CITY OF LONG BEACH

ZONING MEETING PACKET FOR December 13, 2017

STAFF REPORT

Application: (Revised from tabled November application) Variance to construct an approx. ~~16'-14'~~ x 20' storage building approx. 1 ft from a public road easement (min. 30 ft required) and ~~1645~~ ft from Lake Minnewaska (min. 50/75 ft required) and a 1,825 sq ft patio addition (for future conversion to an enclosed structure) with associated grading/fill approx. 18 ft from Lake Minnewaska (min. 50/75 ft required) on a lot that exceeds impervious coverage limits.

Patio Expansion to be 1825 Square Feet

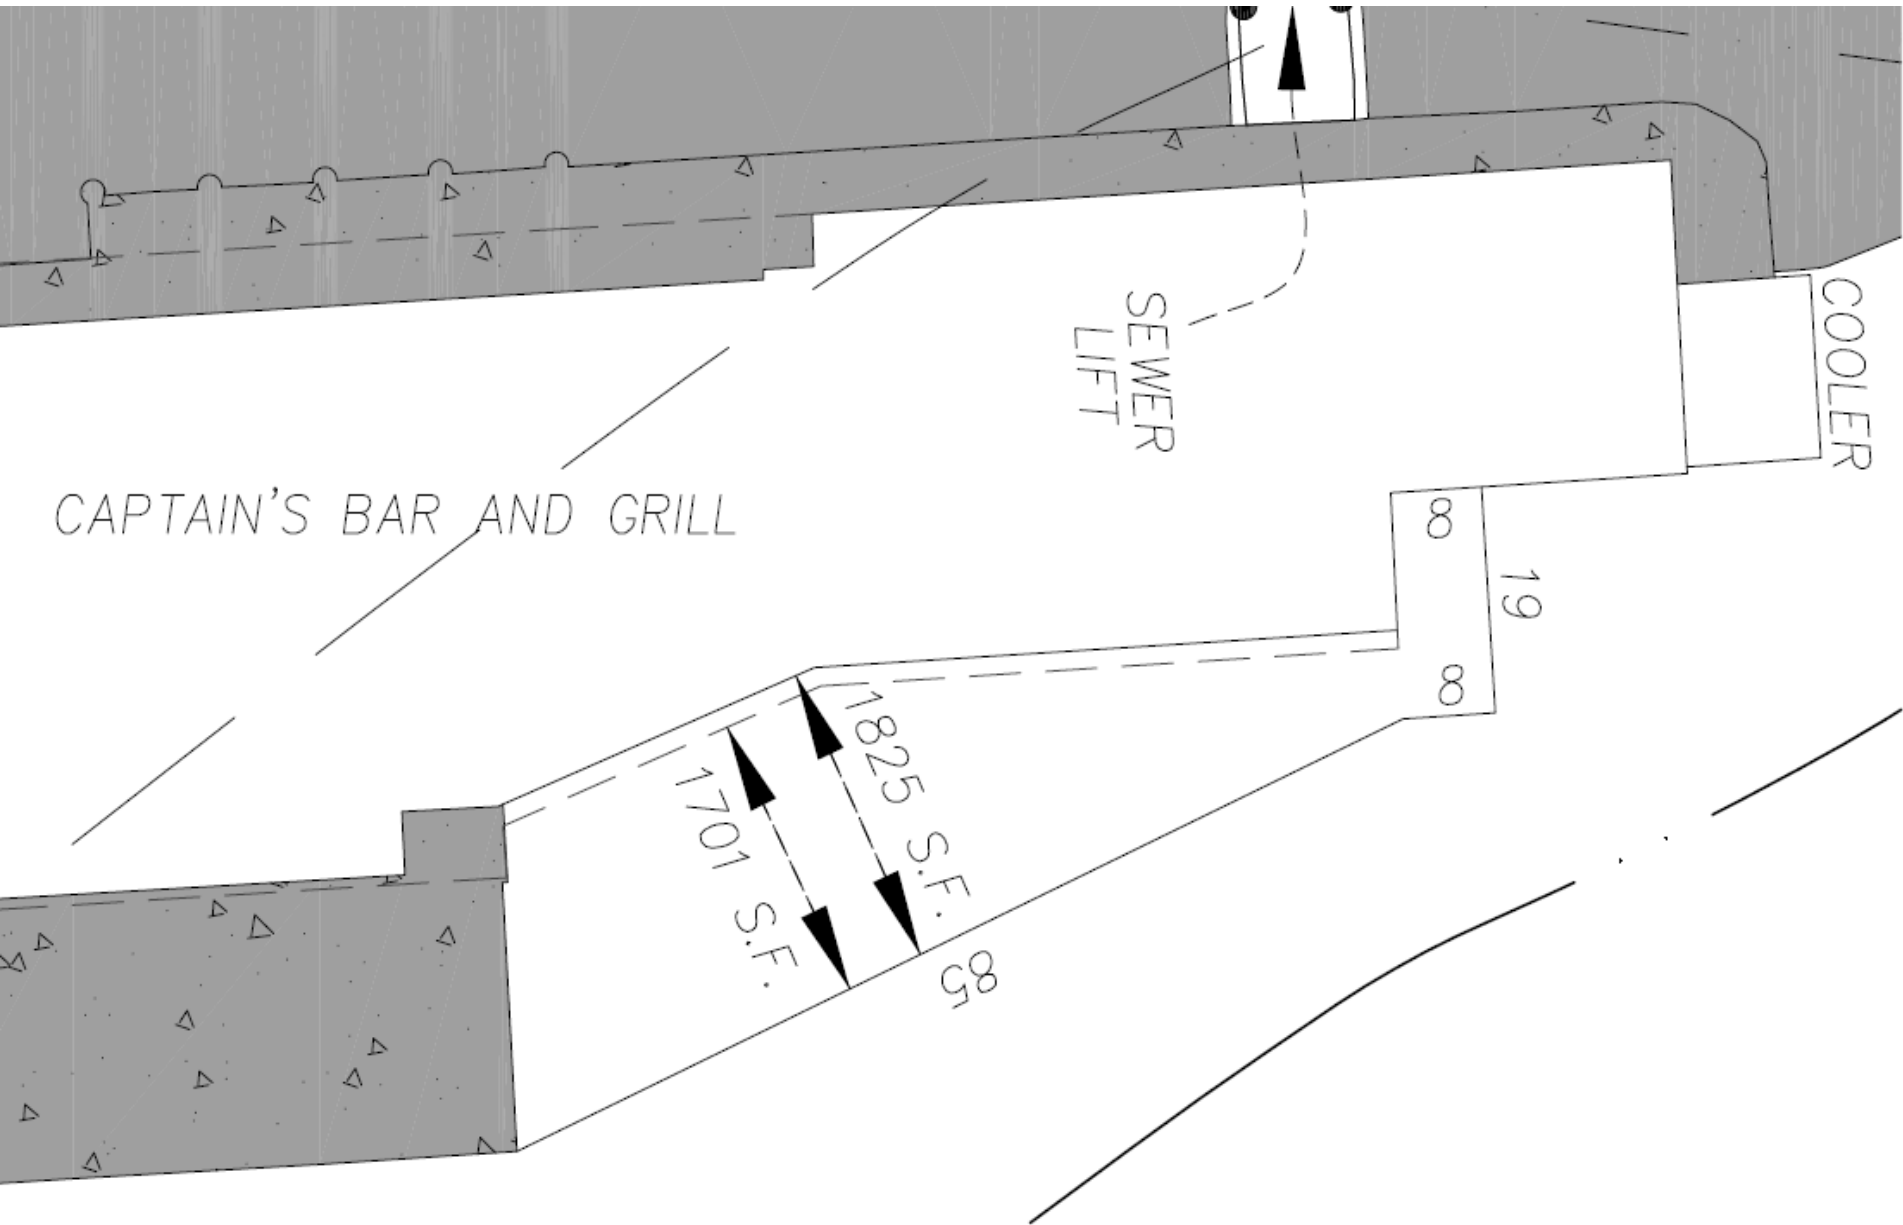
The proposed setback of 45-foot setback from the lake for the storage building and 18 feet for the patio structure would not seem to meet the intent of the ordinance in that it would place structures very close to the lake. However, the existing bar/restaurant structure is also very

The proposed increase in impervious coverage on the lot is inconsistent with the ordinance in that the existing coverage already greatly exceeds the maximum allowed. Given that all of the existing impervious coverage, however, is a legal nonconformity in that it pre-existed the ordinance requirements, it may be possible to argue that adding additional impervious would be consistent with the ordinance provided that an equal amount of impervious that is being added is reduced elsewhere on the lot. The applicant has not proposed this “trading” of impervious coverage however, and it appears unlikely that they would be able to do so without losing needed parking area. Instead, the applicant has proposed constructing the new patio (which would now be the only new impervious on the lot after the location for the proposed shed has been changed to an area already covered by impervious surface) from pervious pavers so that the potential impact of the additional impervious will be mitigated to some degree by allowing water to soak in between the paver stones.

The applicant's revised proposal would not eliminate impervious elsewhere on the lot, but is proposing the installation of a rain garden and paver patios that would be designed to infiltrate water instead of having it run directly toward the lake. This has not been engineered to handle a specific amount of rainwater – just to be able to infiltrate more than would otherwise occur.

2. That the lakeside addition to the building be limited to an open patio or deck, and not be allowed to be roofed (except for the use of temporary awnings or pergola-type structures).
3. That the storage building be located no closer than ~~25~~37.5 feet from the lake (i.e. out of the "shore impact zone" as defined by DNR regulations).

Shed Location – End of the building to the left of the 2 poles.

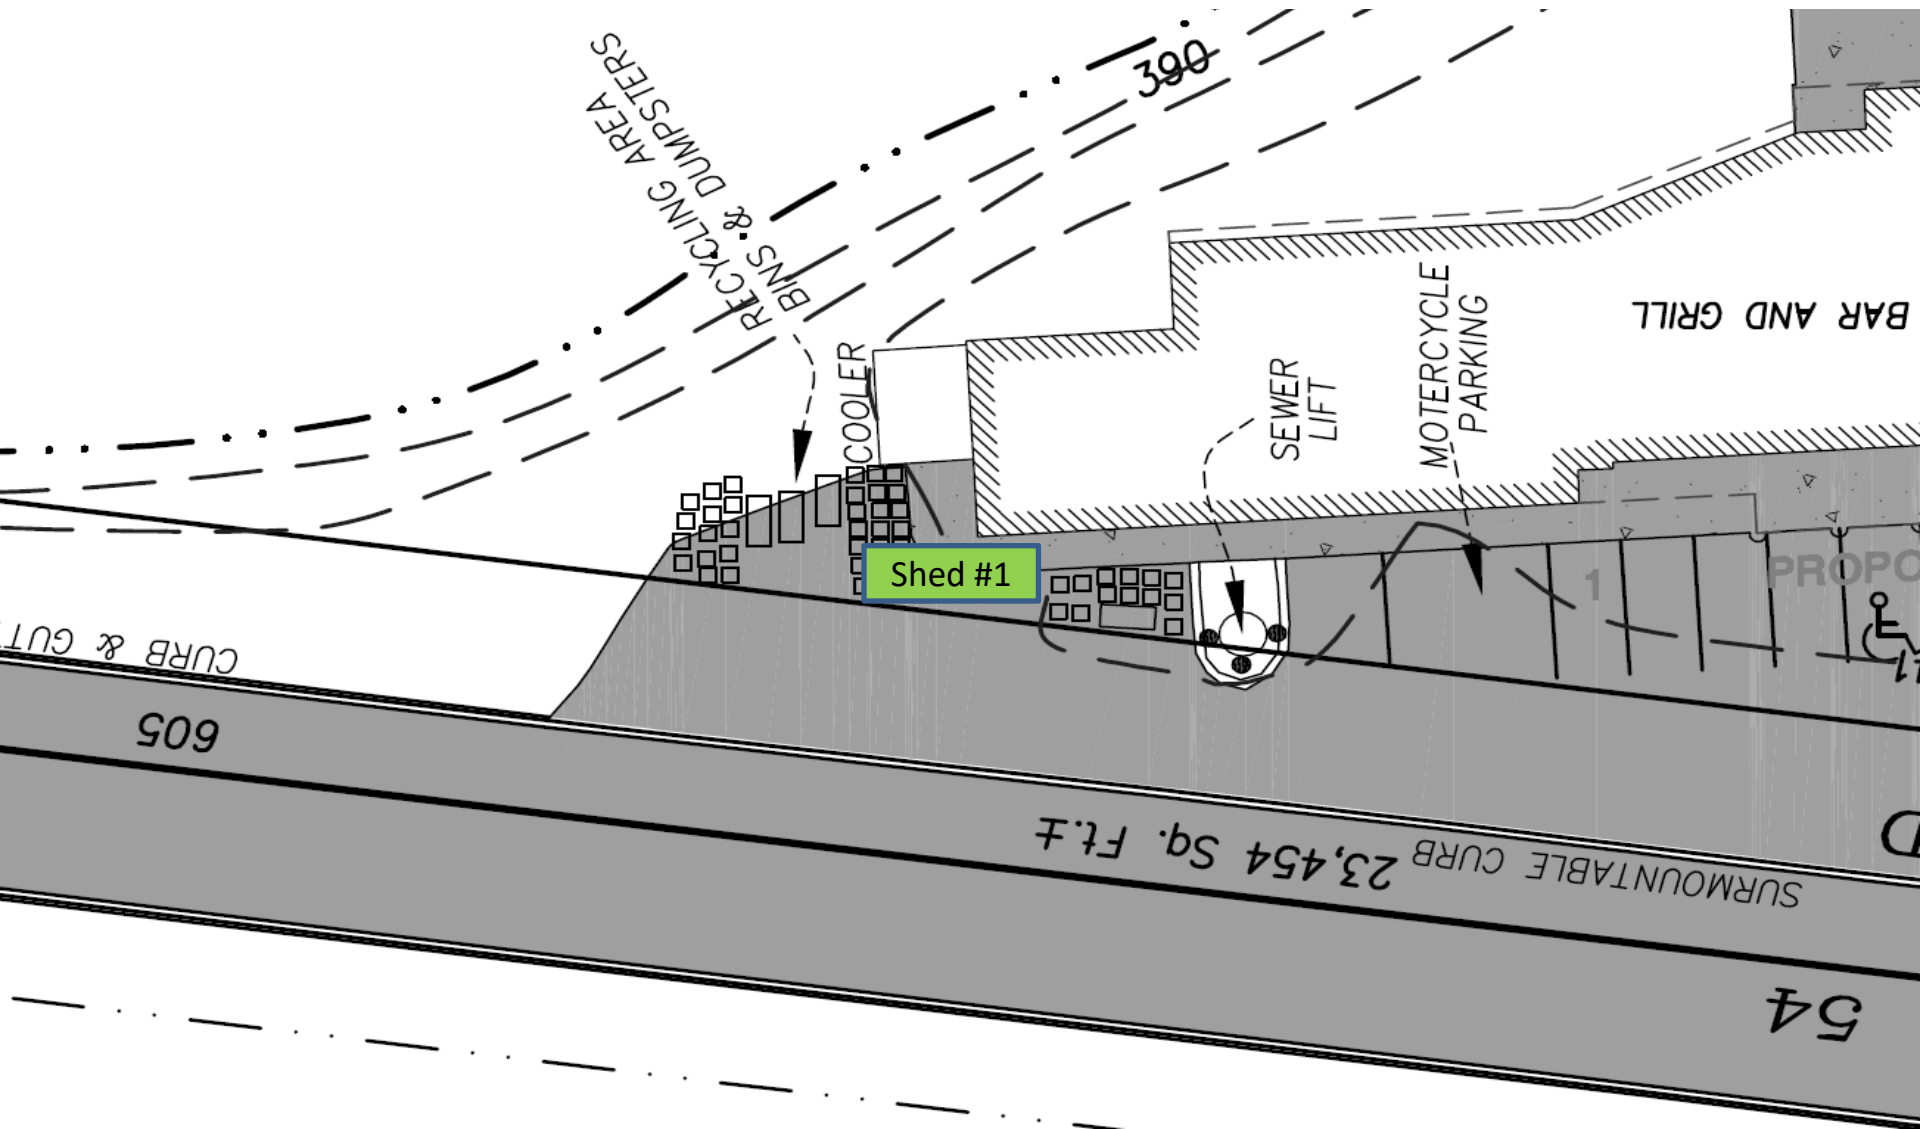
The application is a revision of the application that was tabled at the November meeting of the Planning Commission. The changes to the original plan were to move the proposed shed significantly further from the lake (from a 16-foot to a 45-foot lake setback) and closer to the road, such that a front yard setback variance is now required (1-foot setback vs required 30-foot setback).

3. Alternate Shed Location - Change to a 14'x20' in size [from 16' x 20' in original application]
 - a. I met with Brian the County Engineer and he would like to maintain the 33' easement.
 - b. From the center of the center yellow line we have a little over 48 feet to the building and this includes going up and over the sidewalk.
 - c. So I'm proposing a 14' wide shed and putting it up on the side walk closer to the building. This will allow a little over a foot between the road easement and new shed.
 - d. This will be located further off the road than the High Line Poles and Existing City Sewer Grinder Station

BELGARD PERMEABLE PAVER DETAIL

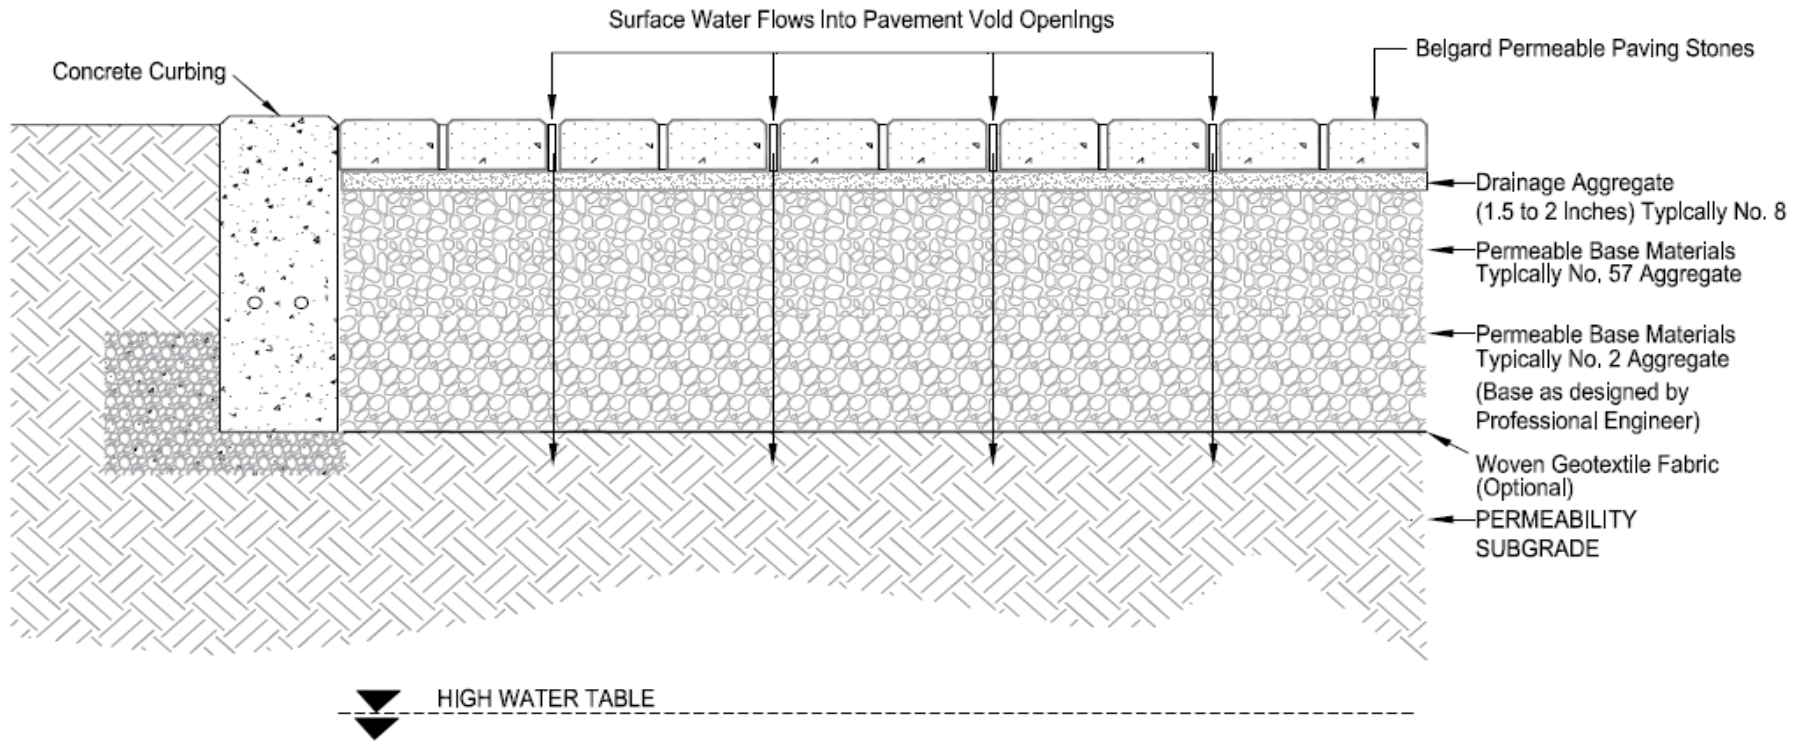
The revision also includes additional information on how the proposed patio would be constructed from pervious pavers so as to minimize the impact of the additional impervious surface on the lot and additional information on the size of the proposed patio (1,825 sq ft as measured to the foundation, 1,701 sq ft as measured to the overhang of the roof).
